ADDENDUM NO.	**1**	DATED	**2/17/2022**	ADDENDUM NO.		DATED	
ADDENDUM NO		DATED		ADDENDUM NO.		DATED	
ADDENDUM NO		DATED		ADDENDUM NO.		DATED

Number	Description
1	Revised Table of Contents; Revised NTB No. 3775; Added Notice to Bidder Nos. 3713, & 4061; Added S.P No. 907-207-2; Revised Bid Items; Revised Progress Schedule; Revised Plan Sheet Nos. 8001, 8032, 8043, 8051, 8059, 8097, 8098 & 8099; Amendment EBSx Download Required.

PROJECT: STP-0050-01(034)/106984301 - Calhoun

Bridge Replacements on SR 9 (Bridge Nos. 35.5, 40.7, 40.9 & 41.2), known as Federal Aid Project No. STP-0050-01(034) / 106984301 in Calhoun County.

Figure 1. Settlement Plate Assembly Detail

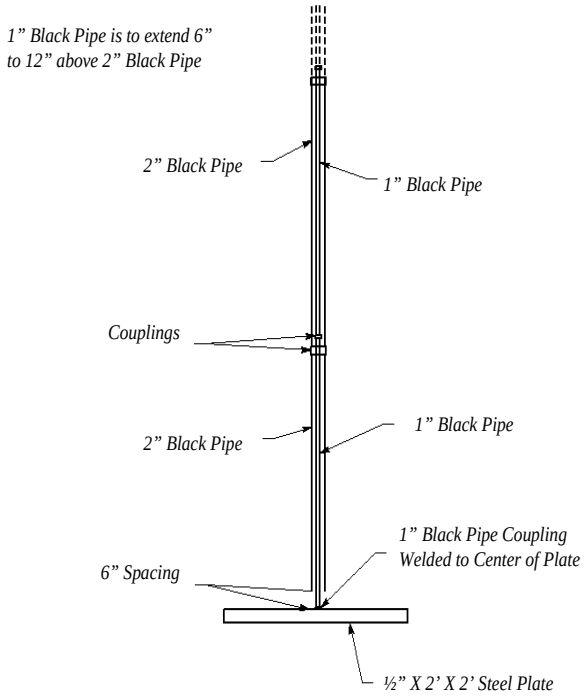
Bidders are hereby advised that the Summary of Quantities sheets in the Plans do not include pay item no. 907-207-A001, Settlement Plate. This is in error. A quantity of **12 EA** for this pay item has been added to the bid items.

After Subsection 207.02.3 on page 123, add the following figure.

INTERMEDIATE BENTS NO. 3 THRU 5
DRILLED SHAFTS DETAILS

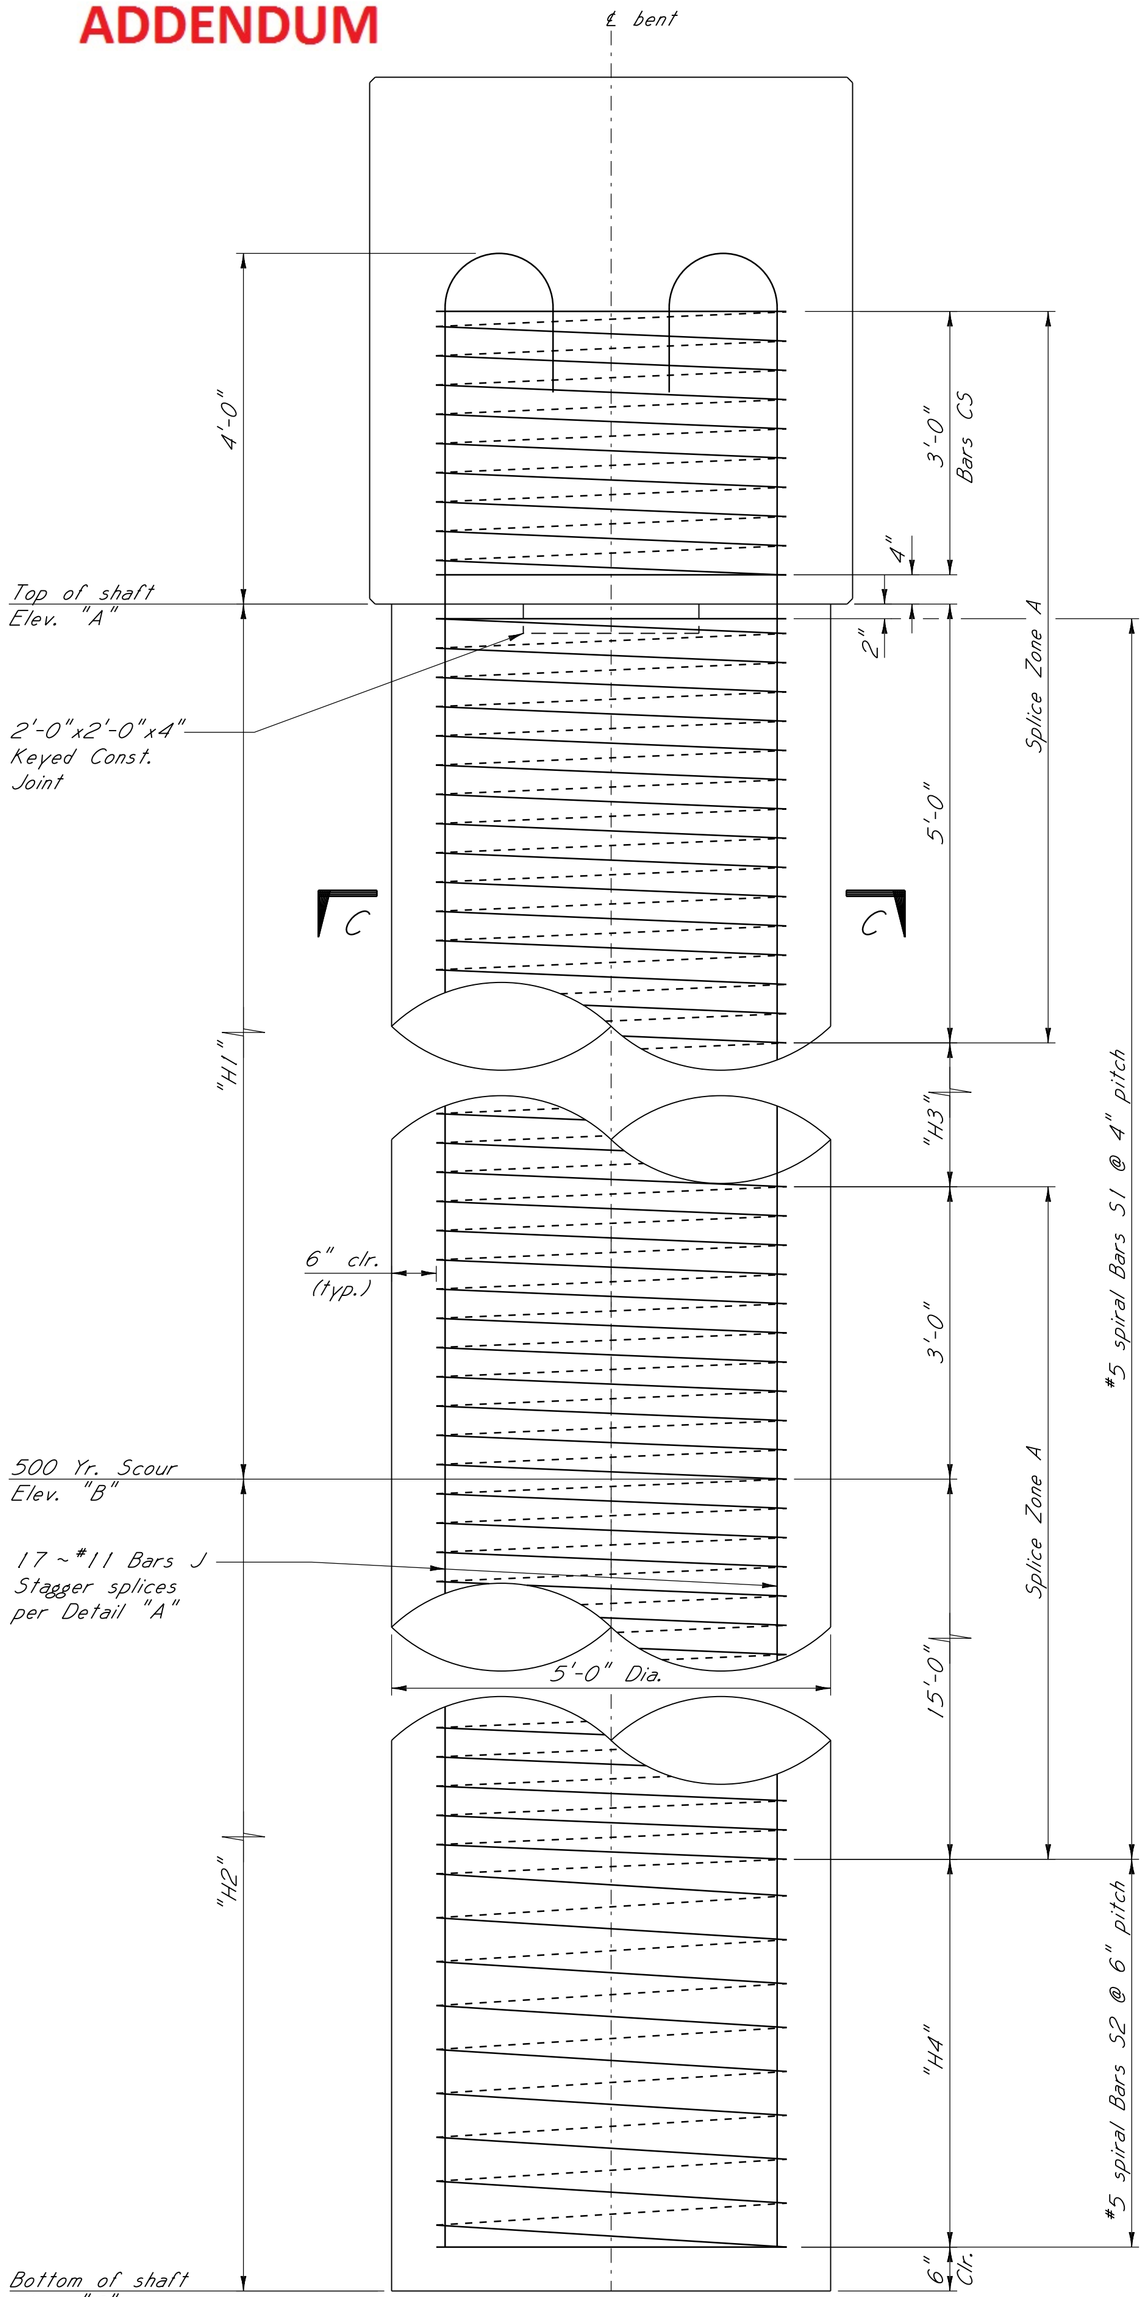
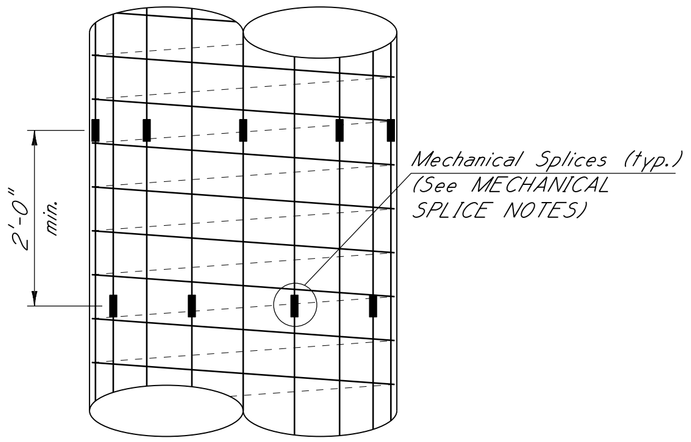
BY	DATE	REVISIONS
JDM	02-08-22	Revised Values in Table

Bent No.	Shaft No.	Elev. "A"	Elev. "B"	Elev. "C"	"H1"	"H2"	"H3"	"H4"	"JL"	"S1L"	"S2L"
3	1	251.3958	238.70	201.3958	12'-8 3/8"	37'-3 5/8"	4'-8 3/8"	21'-9 5/8"	53'-6"	27'-6 3/8"	21'-9 5/8"
	2	251.8437	238.70	201.8437	13'-1 3/4"	36'-10 1/4"	5'-1 3/4"	21'-4 1/4"	53'-6"	27'-11 3/4"	21'-4 1/4"
	3	252.2864	238.70	202.2864	13'-7 1/16"	36'-4 15/16"	5'-7 1/16"	20'-10 15/16"	53'-6"	28'-5 1/16"	20'-10 15/16"
4	1	251.4672	202.80	151.4672	48'-8"	51'-4"	40'-8"	35'-10"	103'-6"	63'-6"	35'-10"
	2	251.9099	202.80	151.9099	49'-1 5/16"	50'-10 11/16"	41'-1 5/16"	35'-4 11/16"	103'-6"	63'-11 5/16"	35'-4 11/16"
	3	252.3579	202.80	152.3579	49'-6 1/16"	50'-5 5/16"	41'-6 1/16"	34'-11 5/16"	103'-6"	64'-4 1/16"	34'-11 5/16"
5	1	251.7990	202.80	151.7990	49'-0"	51'-0"	41'-0"	35'-6"	103'-6"	63'-10"	35'-6"
	2	252.2417	202.80	152.2417	49'-5 5/16"	50'-6 11/16"	41'-5 5/16"	35'-0 11/16"	103'-6"	64'-3 5/16"	35'-0 11/16"
	3	252.6897	202.80	152.6897	49'-10 1/16"	50'-1 5/16"	41'-10 1/16"	34'-7 5/16"	103'-6"	64'-8 1/16"	34'-7 5/16"

MISSISSIPPI DEPARTMENT OF TRANSPORTATION
BRIDGE AT STA. 1245+18.92
490 FT. CONT. STEEL GIRDER SPAN
TYPICAL SECTION

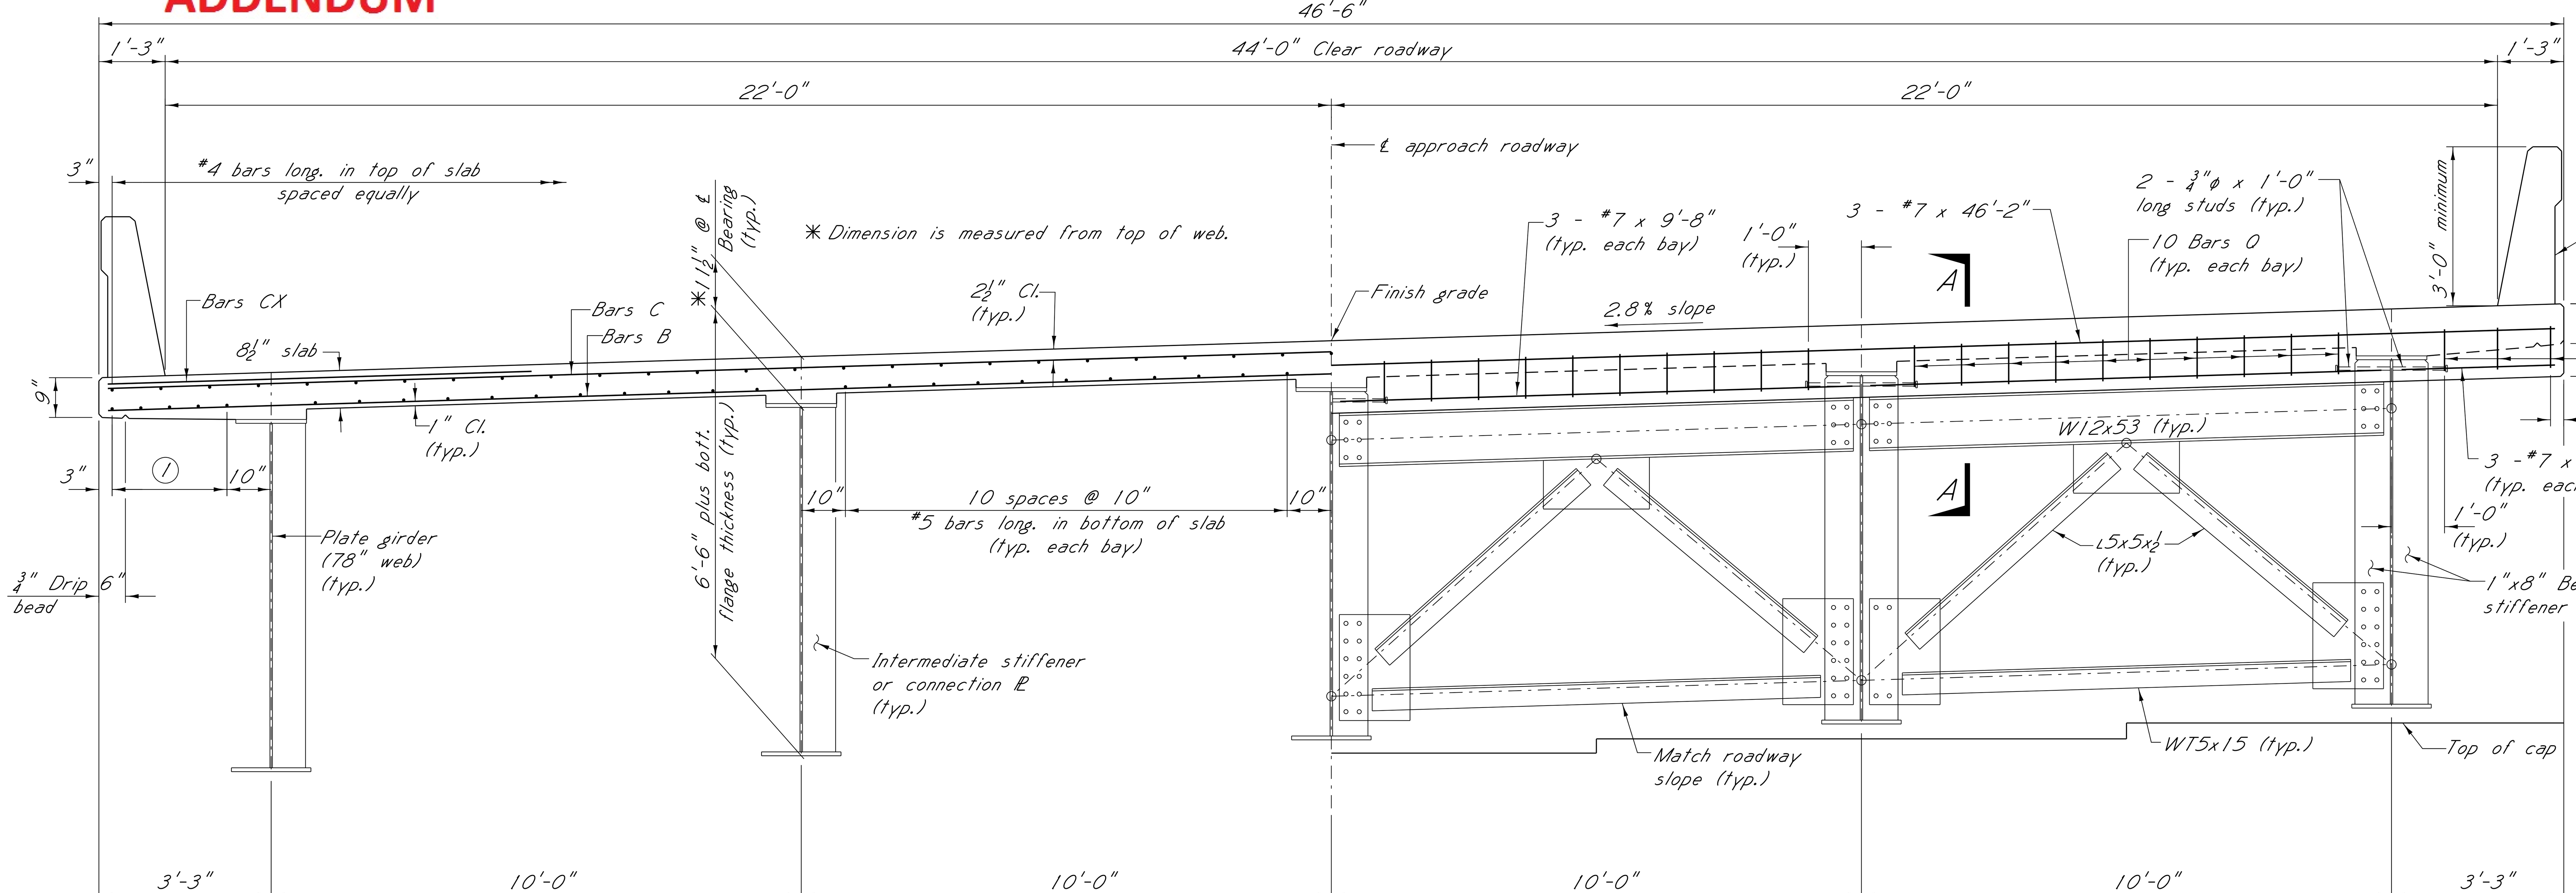
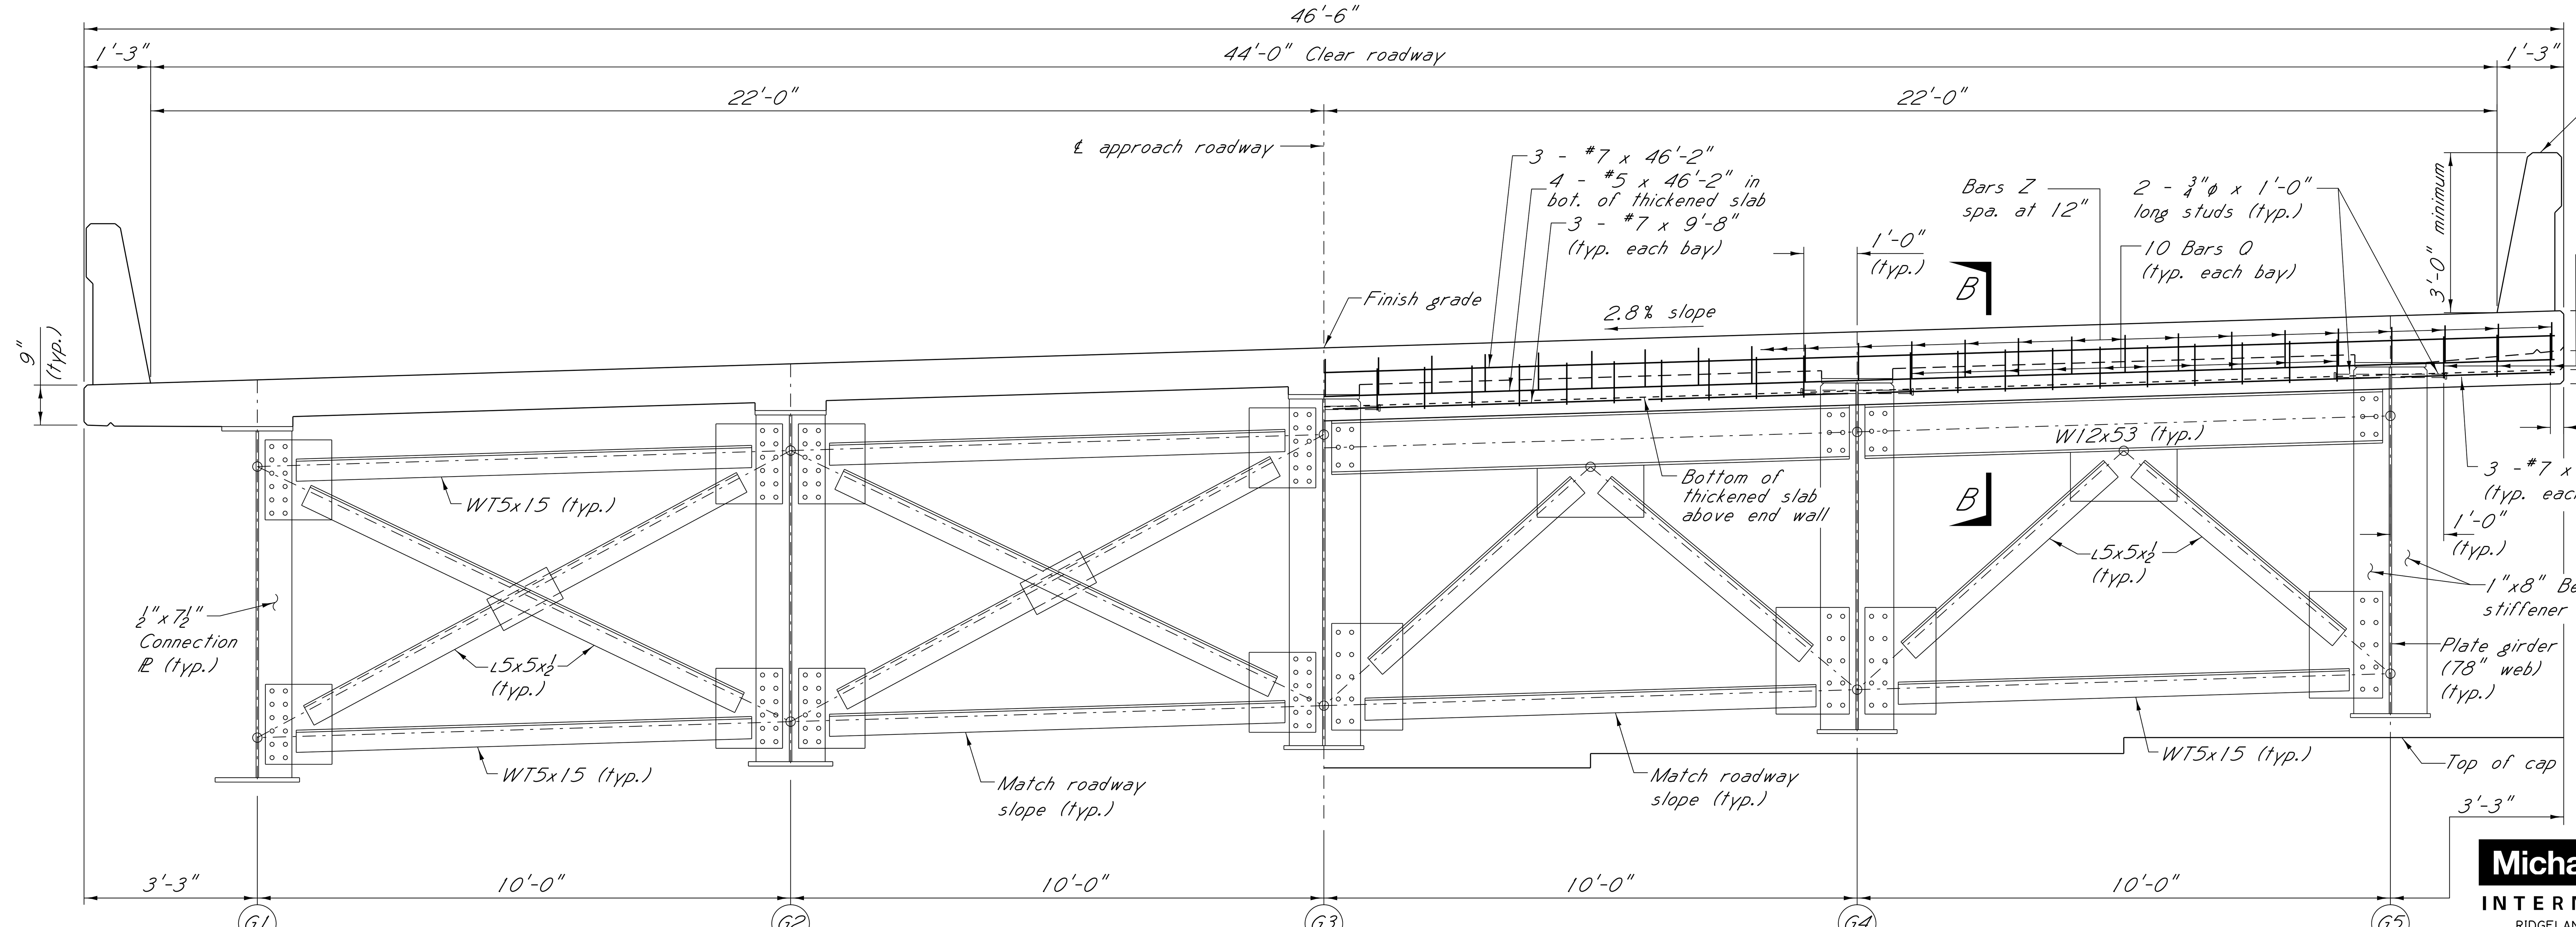
DATE	REVISIONS	BY
02-16-22	Removed "HPS" designation from Structural Steel material	JDM

DESIGN DATA:
Specifications . . . . A.A.S.H.T.O., LRFD 8th Edition 2017 with 2018 Interims
Loading HL-93
Stay in place metal forms . . . 18 lbs/sq. ft.
Structural Steel . . . . ASTM A709, Grade 50W (Fy = 50 ksi)
Concrete in Deck . . . . Class "BD" (4,500 p.s.i)
Concrete in Railing . . . . . . Class "AA" (4,000 p.s.i)

SHEET NUMBER 8059

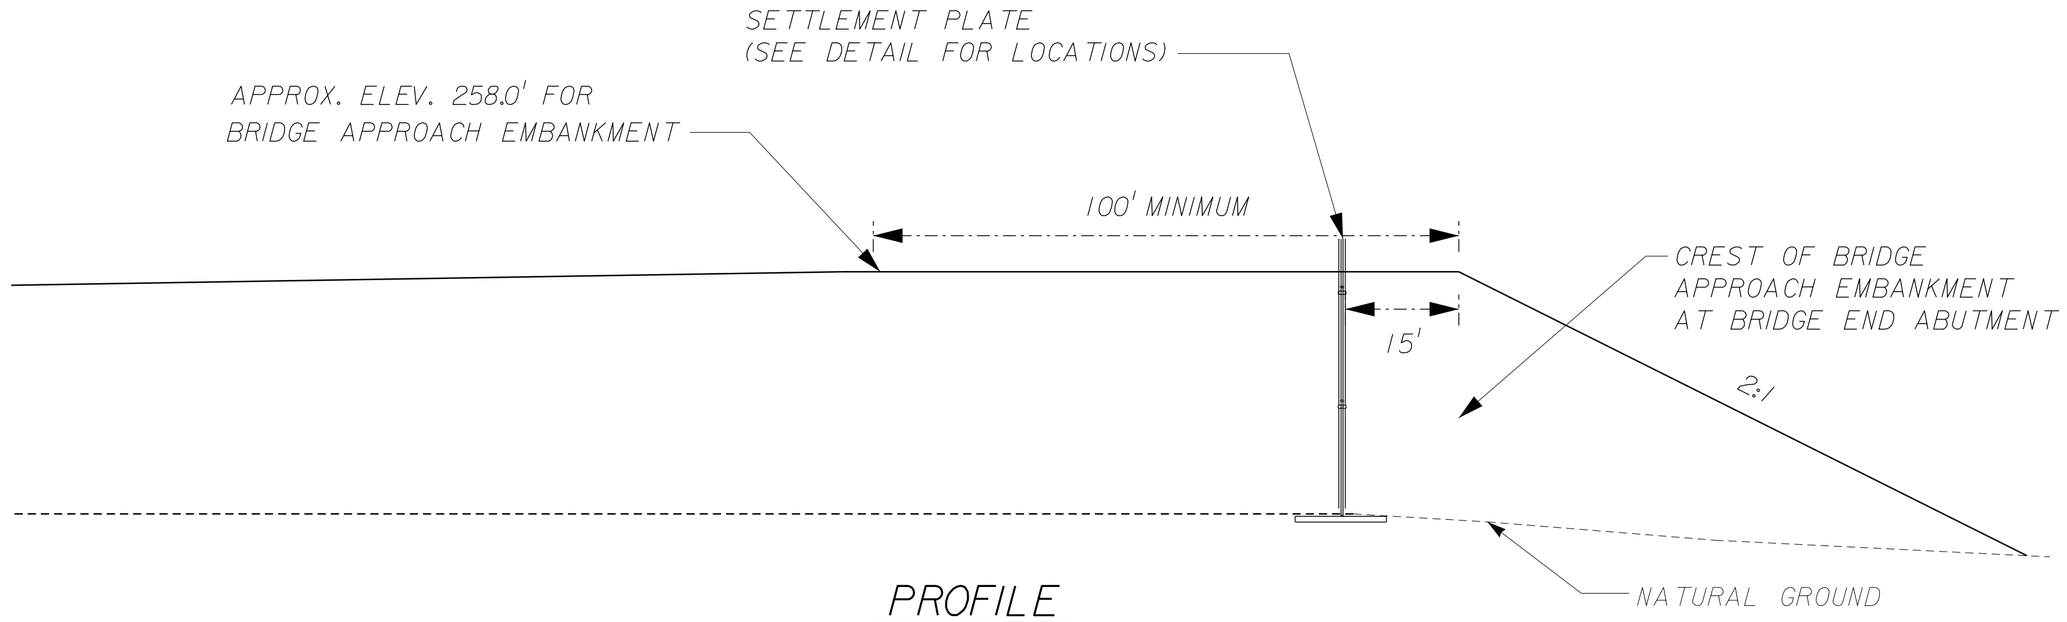
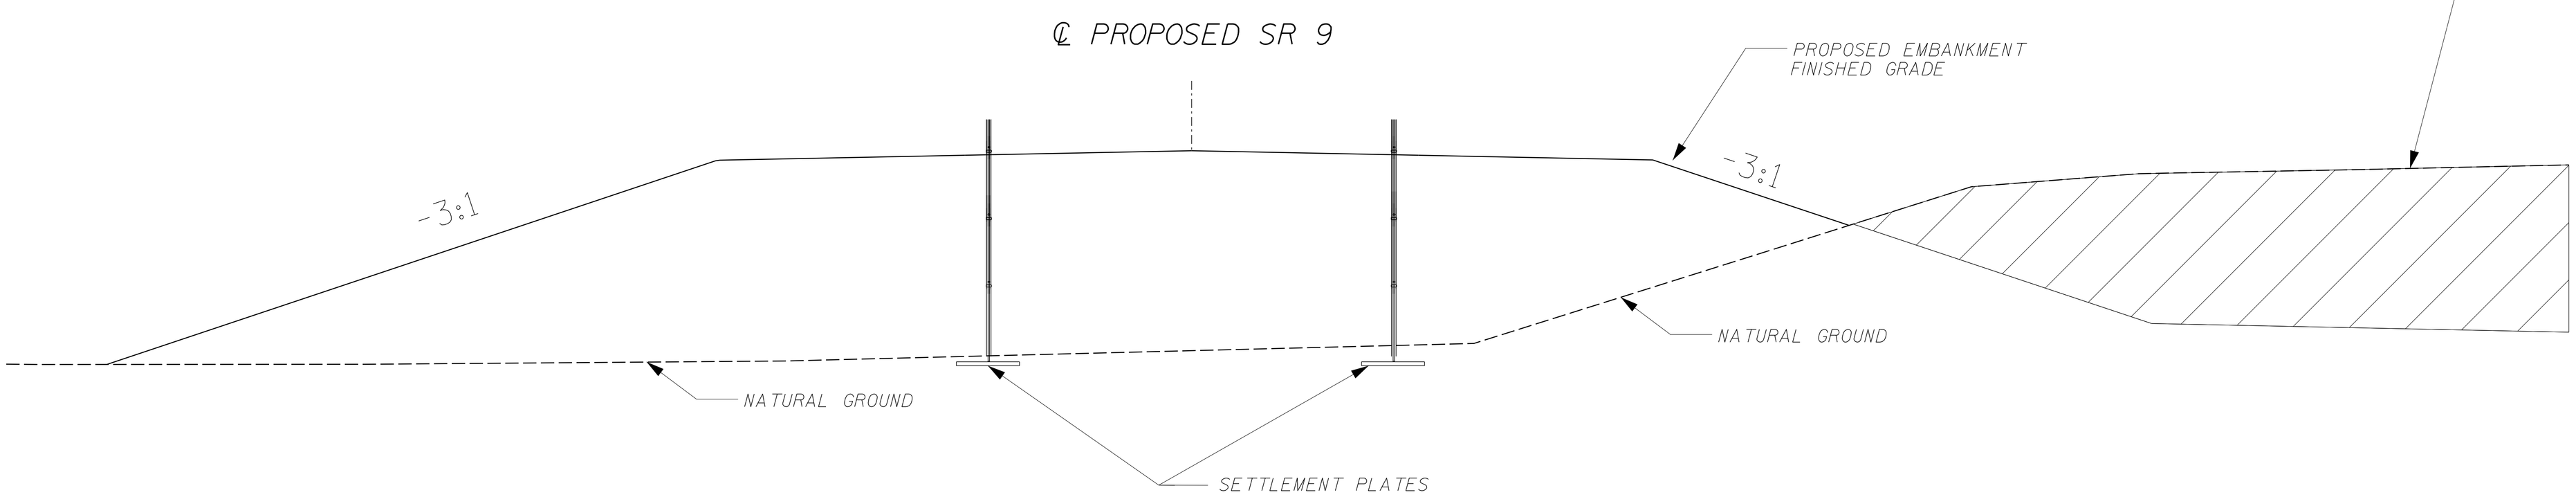
⚠1 ADDED SETTLEMENT PLATE SHEET

BY	REVISIONS	DATE
IHL	⚠1 ADDED REVISED SHEET	02/16/22
